MEMORANDUM

DATE:	2025-10-10	RWDI Reference No.: 2512374
TO:	Derek Judson	EMAIL: judson@parkin.ca
FROM:	Jordan Gilmour	EMAIL: Jordan.Gilmour@rwdi.com
	Kyle Hellewell	EMAIL: Kyle.Hellewell@rwdi.com
RE:	Noise Design Review Queensway Carlton Hospital Nepean, Ontario

Figure 1: Assessed Point of Reception Locations

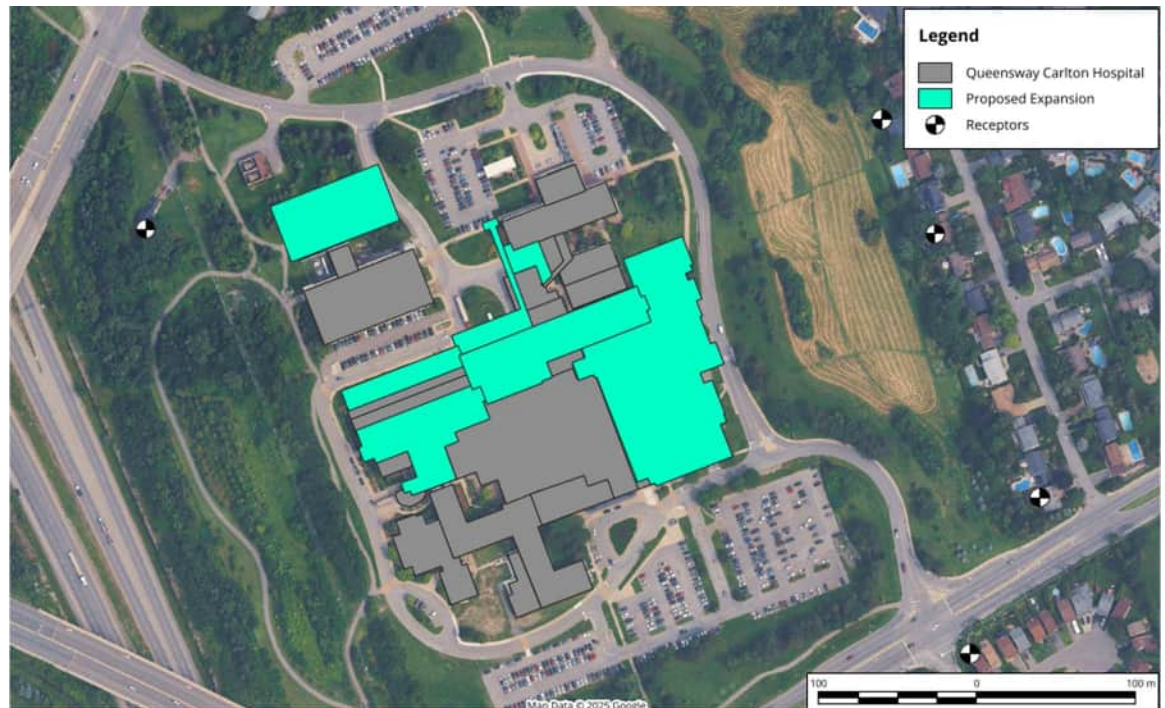
Representative points of reception around the proposed development are evaluated. For typical dwellings an outdoor point is assessed at 1.5 m above grade, and the façade is assessed at the bedroom windows: 1.5 m or 4.5 m for 10 or 2-storey dwellings respectively.

It was confirmed by QCH that there are no operable windows on the façades of the hospital buildings and therefore no points of reception have been assessed at the hospital façades. The representative points of reception assessed for this review are shown in **Figure 1**.
